Number 1  
 Date APRIL 15, 1982  
 Page 1 of 4

Models Affected: ADVANTAGE Class of Change: MANDATORY  
 Assembly(s) Affected: ADV BASE ASSY Field Action: INSTALL ON NEXT CALL  
 Factory Implementation: 5-1-82 Est. Install. Time: 0.5 Hrs.

1. REASON FOR CHANGE

Provide adequate grounding between I/O plate, AC power panel and chassis of Advantage Computer. This change is mandatory to conform to UL & CSA standards. Without this modification, equipment could be damaged under certain short circuit conditions.

FIGURE 1

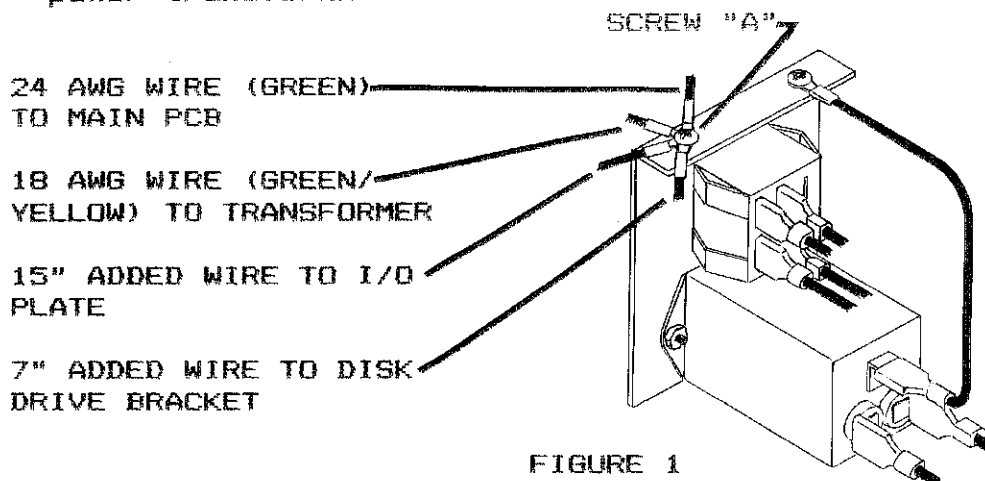
1. Disconnect the Advantage from the AC power source.
2. Remove the top cover of the Advantage as described in Section 6.5.2 of the Advantage Technical Manual (North Star P/N 00464).
3. Using Figure 1 as a reference, remove screw A on the AC power panel. (NOTE: this screw already secures two (2) wires, one solid green 24 awg wire going to the main PCB connector and one green/yellow 18 awg wire going to the power transformer).

FIGURE 2

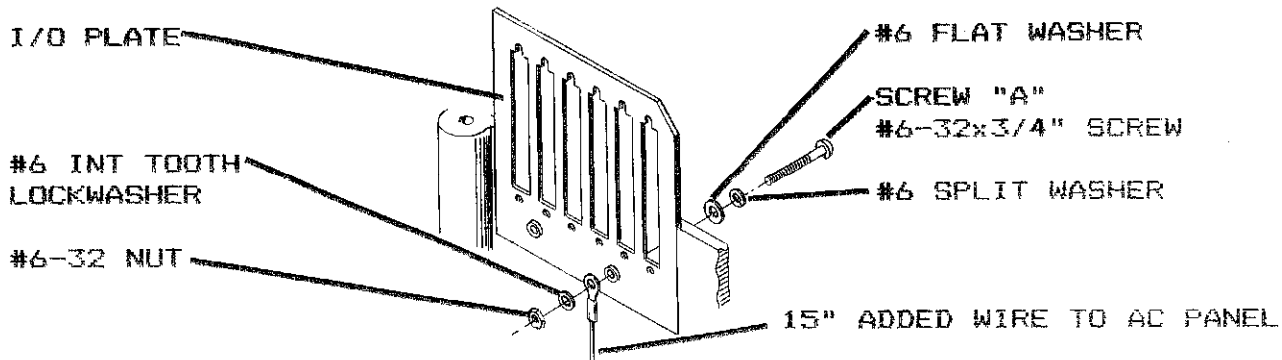
4. Attach one end of each of the two wires supplied in the kit to the screw removed in step 3 along with the two wires already attached to the screw and replace the screw on the AC power panel.
5. Using Figure 2 as a reference, remove screw A on the I/O mounting panel. Discard this screw.

FIGURE 3

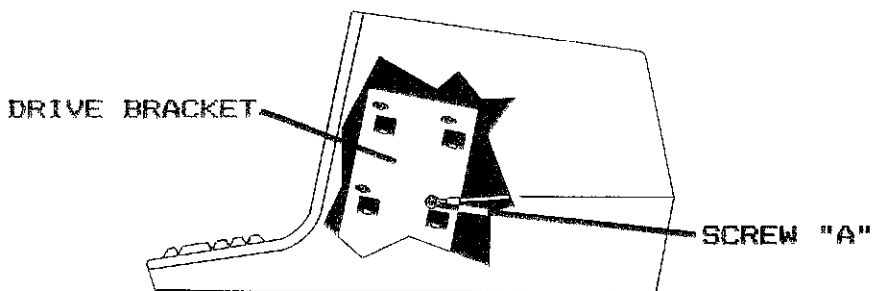
6. Using the hardware supplied in the kit, install the loose end of the 15" wire to the I/O mounting plate as shown in Figure 2.
7. Using Figure 3 as a reference, remove screw A on the disk drive mounting bracket.

8. Connect the loose end of the 7" wire to the drive mounting bracket using the screw removed in step 7.
9. Using a DVM, check to make certain that there is zero ohms between the I/O mounting panel, the disk drive bracket and the AC power panel.
10. Replace the Advantage top cover as described in Section 6.5.2 of the Advantage Technical Manual.

FIGURE 2

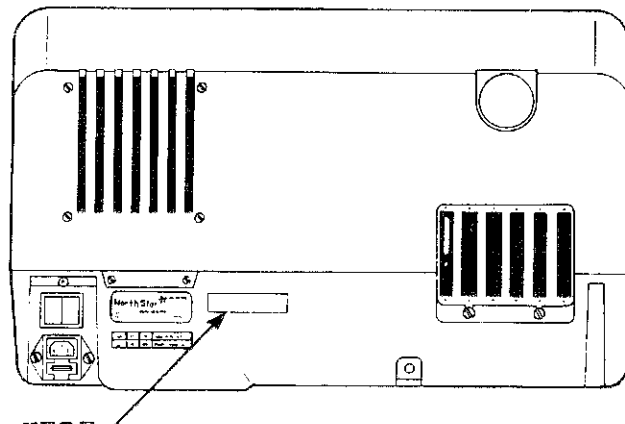
Apply self adhesive FCC sticker (North Star Part Number 02292A) to the rear of all ADVANTAGE computer systems currently in inventory as indicated in Figure 2.

FIGURE 2

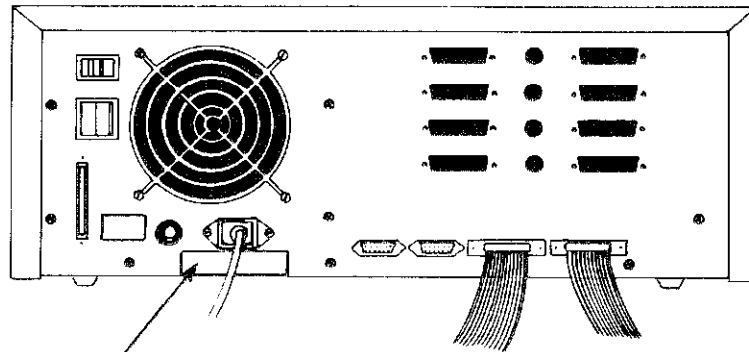
Apply self adhesive FCC sticker (North Star Part Number 02292A) to the rear of all HORIZON computer systems currently in inventory as indicated in Figure 2.

FIGURE 2

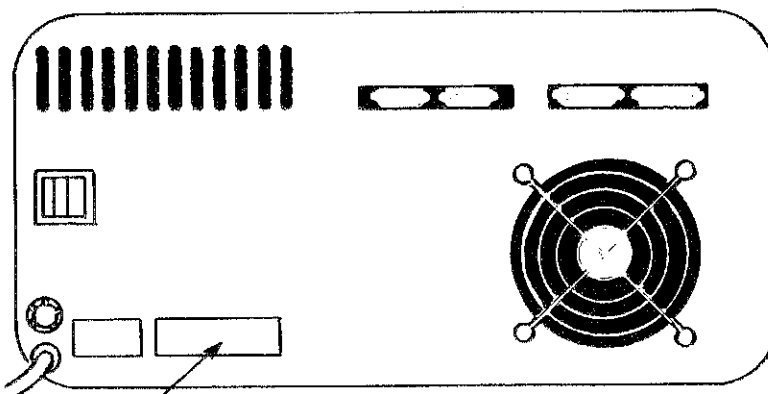
Apply self adhesive FCC sticker (North Star Part Number 02292A) to the rear of all HD-18 hard disk systems currently in inventory as indicated in Figure 2.

FIGURE 2

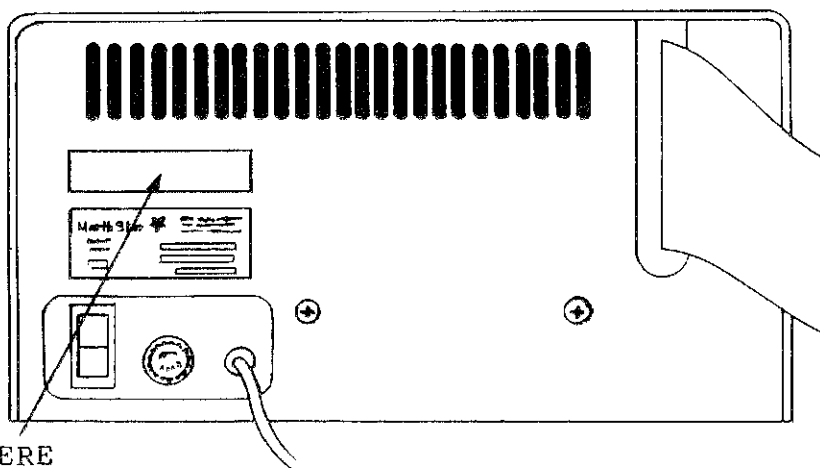
Apply self adhesive FCC sticker (North Star Part Number 02292A) to the rear of all TAPE BACK-UP SYSTEMS currently in inventory as indicated in Figure 2.

FIGURE 1

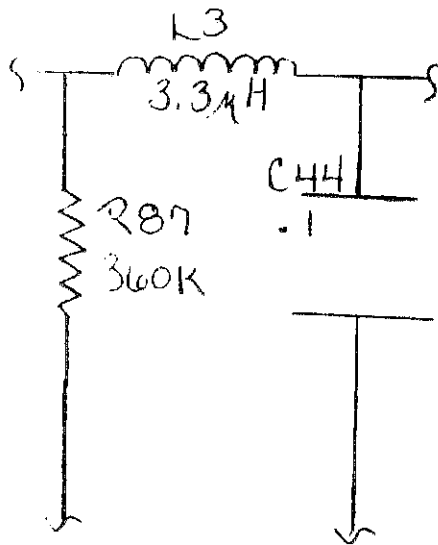
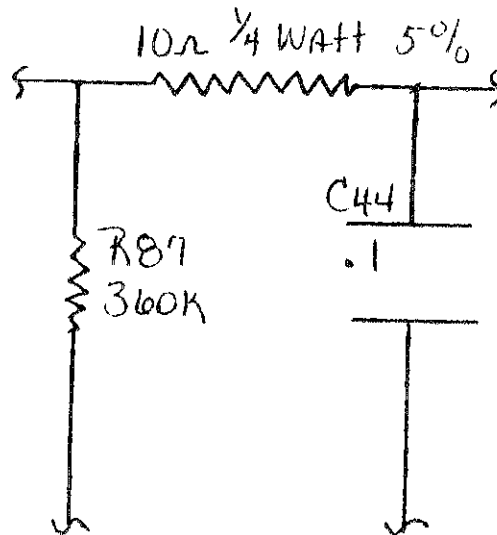
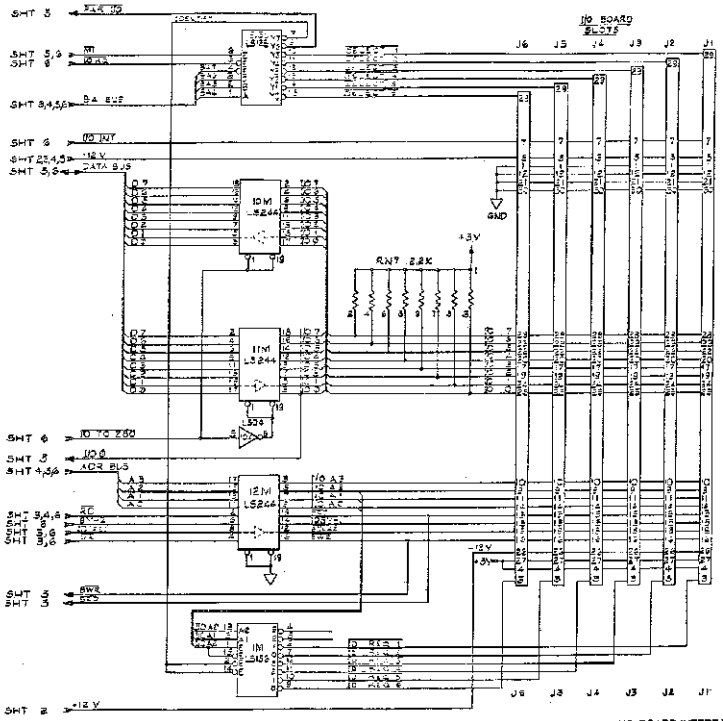
This modification to the ADVANTAGE main PCB will eliminate the half dot shift in the linearity of the lower 2/3 of the ADVANTAGE video screen.

The modification is accomplished by removing L3 (3.3 micro henry coil) located at IC 1A on the main PCB of the ADVANTAGE and replacing it with a 10 ohm 1/4 watt resistor designated R108.

4. Using Figure 1 as a reference, desolder L3 (3.3 micro henry inductor) at location IC 1A on the main PC Board.
5. Remove the excess solder from solder pads and holes.

6. Install resistor (North Star P/N 61053) 10 ohm, 1/4 watt, 5% in place of L3.
7. Replace ADVANTAGE top cover as outlined in Section 7.3.1 of the ADVANTAGE Technical Manual.

**NorthStar**  
 ADVANTAGE  
 VAN FOR  
 SCHEMATIC  
 00100 S

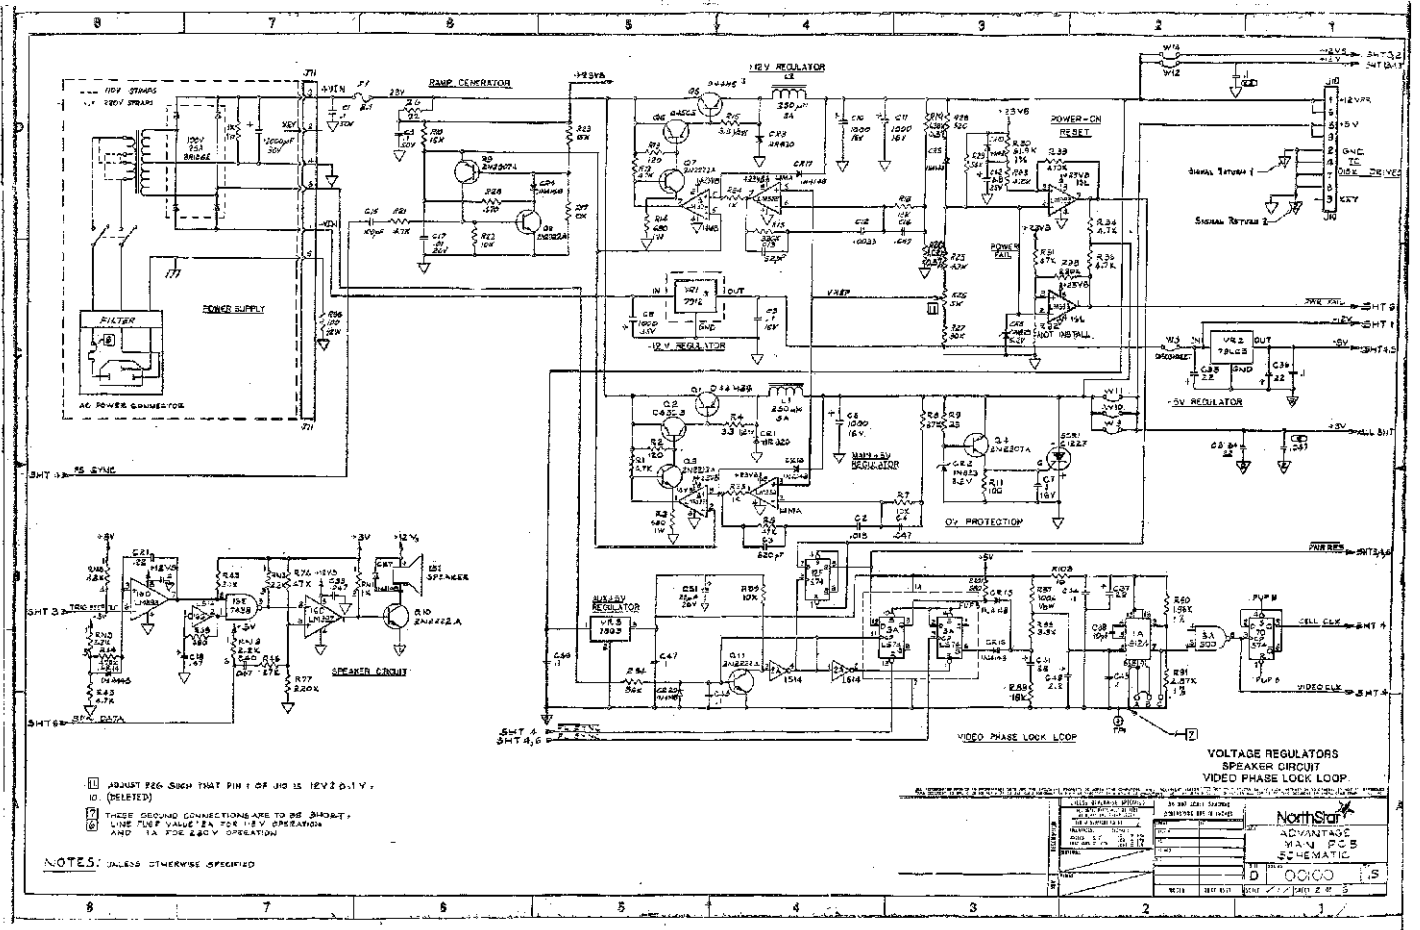
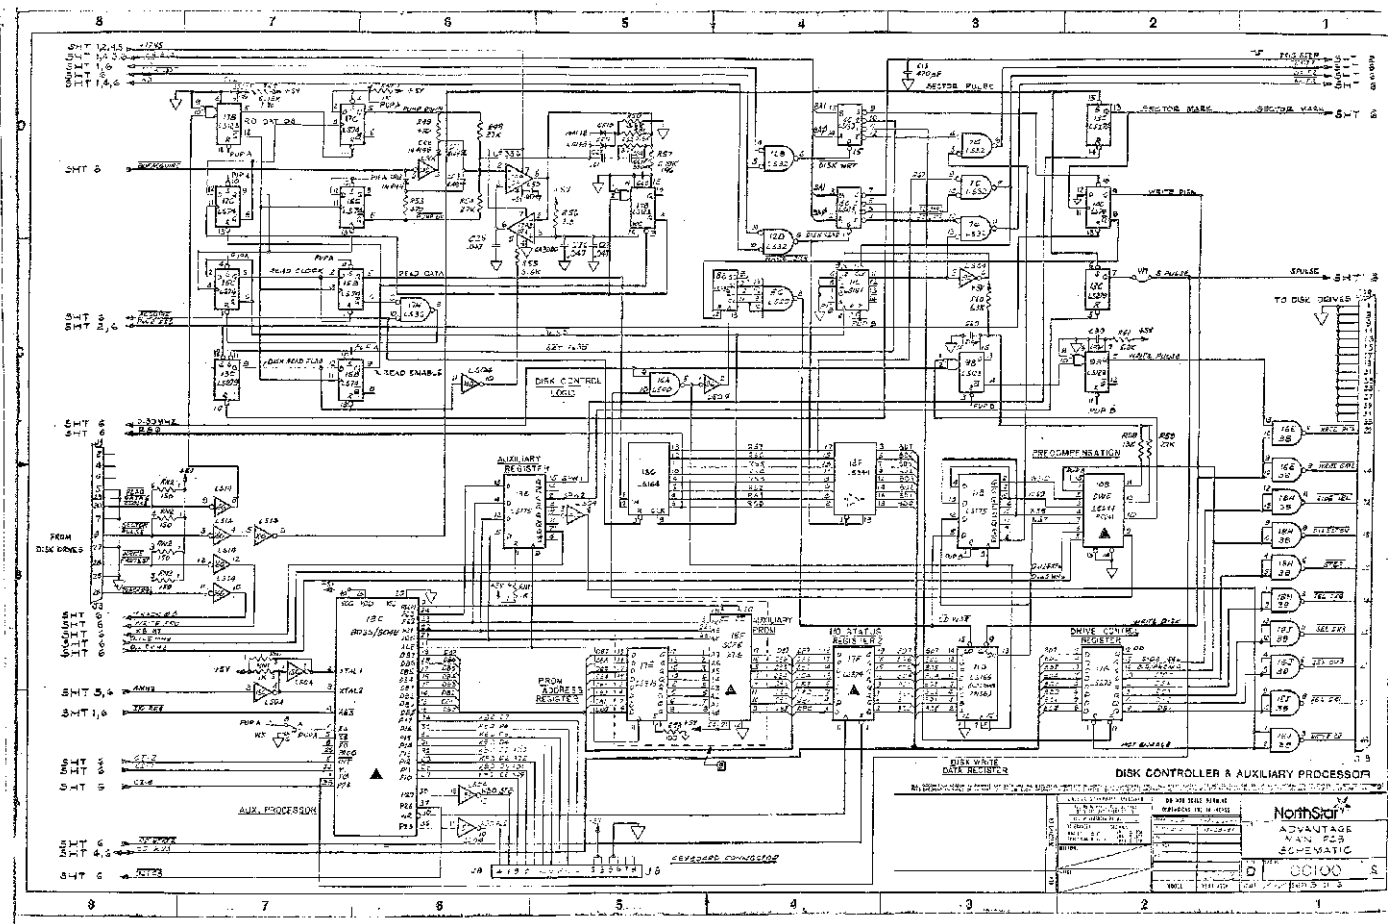
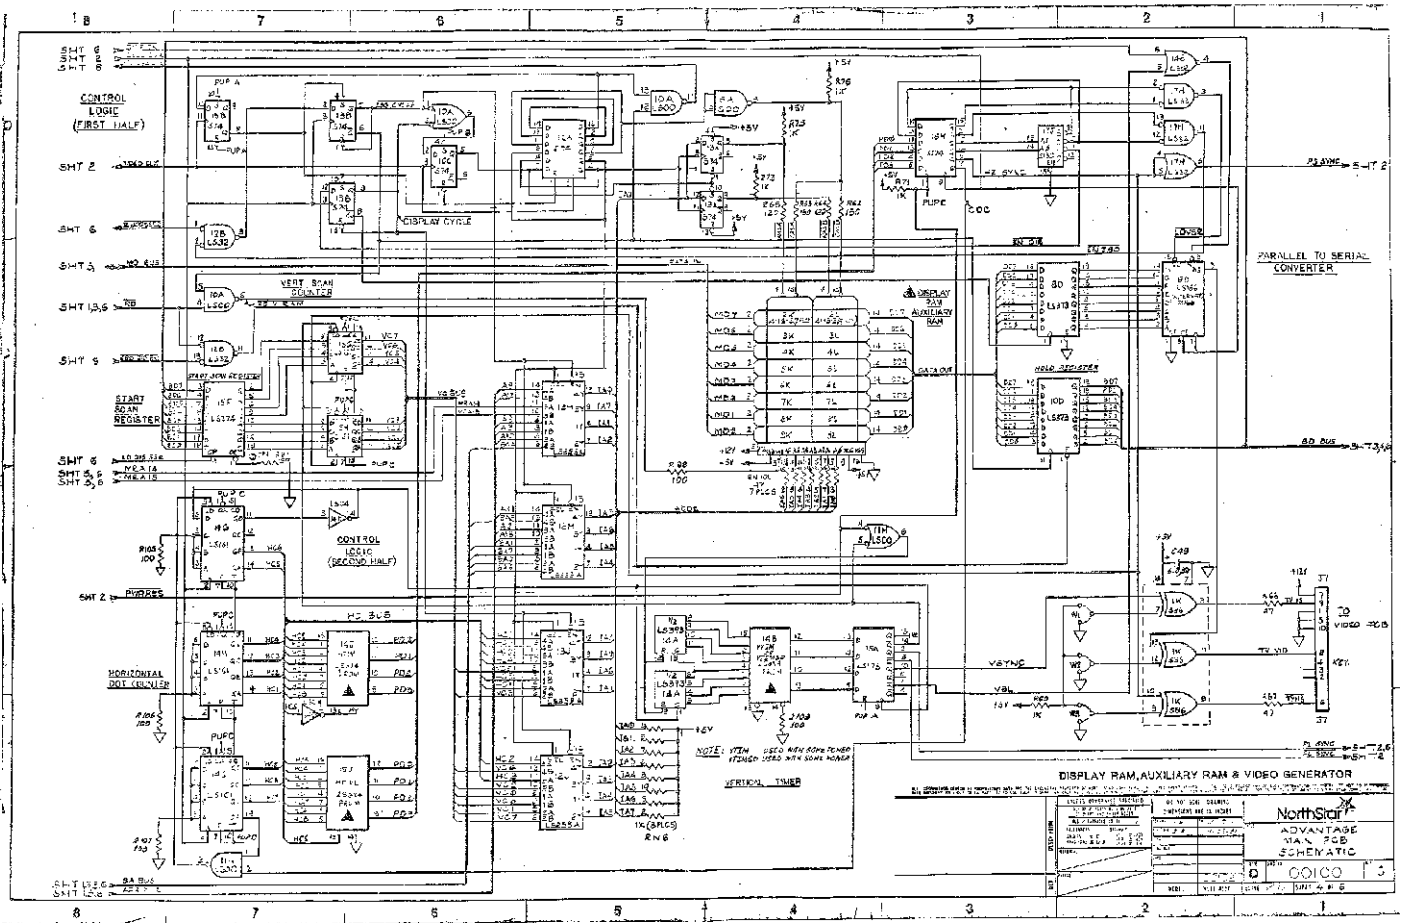
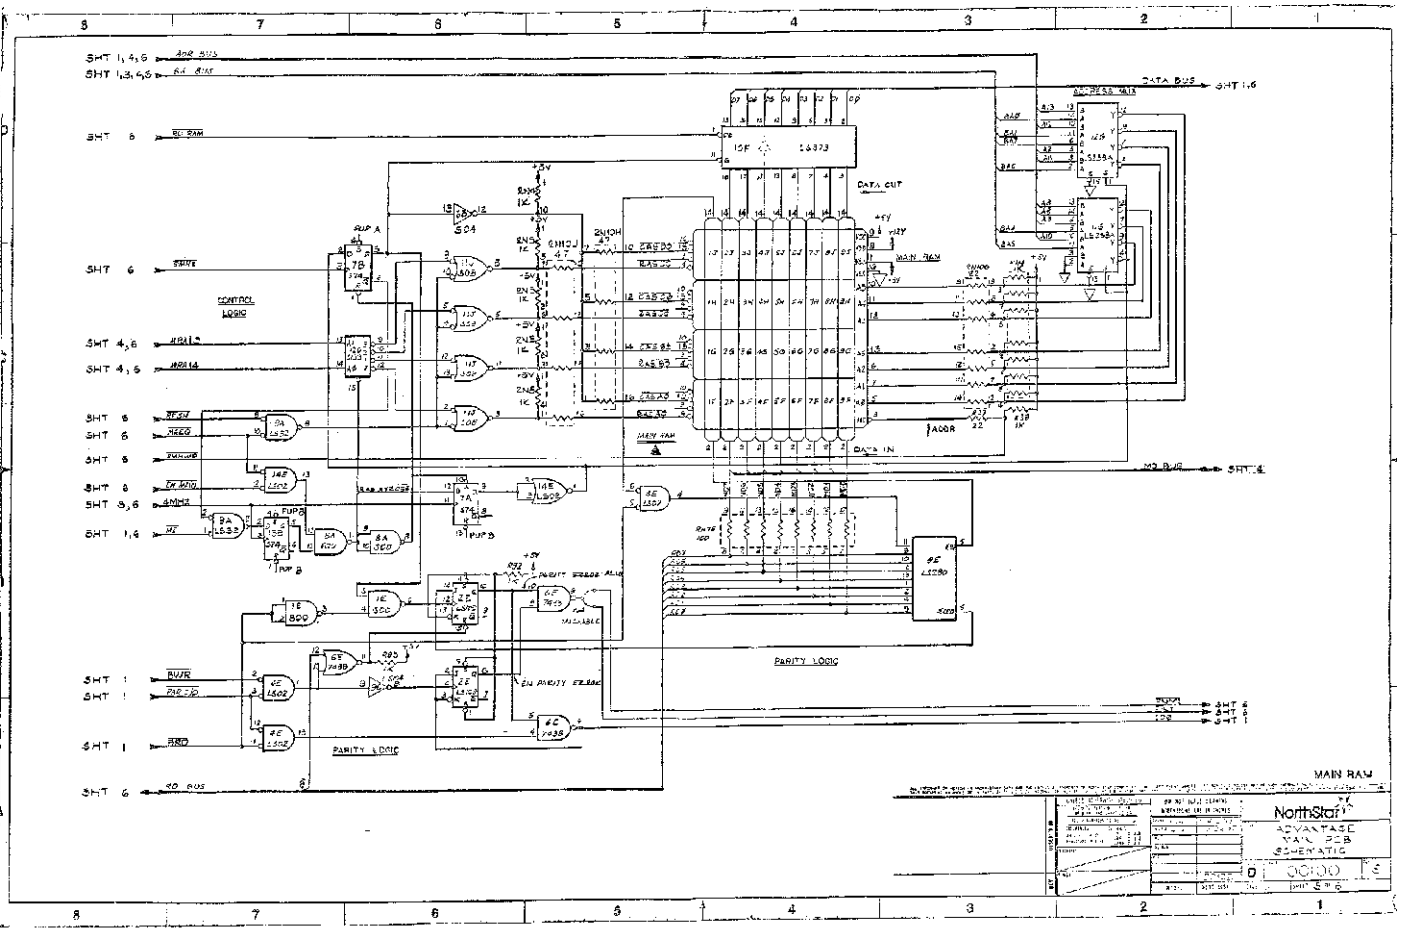
Schematic, ADVANTAGE Main PCB (North Star Drawing #00100)  
from Revision P to Revision S (copy attached)
